SAFETY ALERT

Subject: Corrected chart for RNAV (GPS) RWY 18, Amdt 2A at Portland INTL Jetport
(PWM), Portland, ME

RNAV (GPS) RWY 18

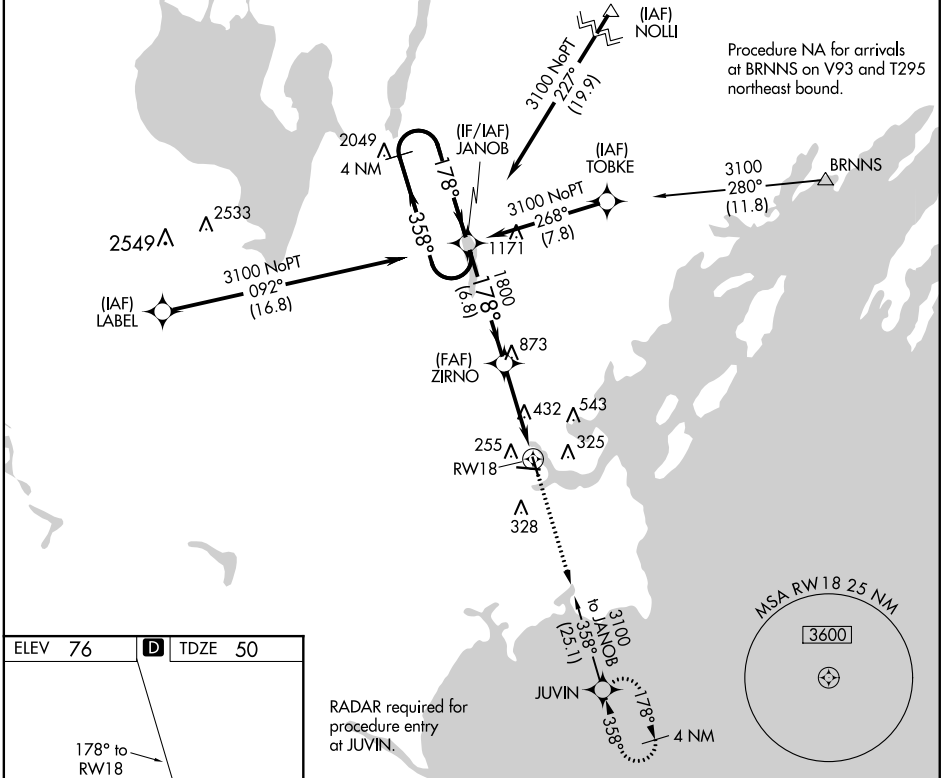
The RNAV (GPS) RWY 18 chart at Portland INTL Jetport (PWM), Portland, ME, depicts the coastline incorrectly in the Terminal Procedure Publication, NE-1 volume and the digital-Terminal Procedures Publication, effective December 30, 2021 (2113) and January 27, 2022 (2201). The corrected chart will be published on February 24, 2022.

Attached is the correct file for RNAV (GPS) RWY 18, AMDT 2A at Portland INTL Jetport (PWM), Portland, ME.
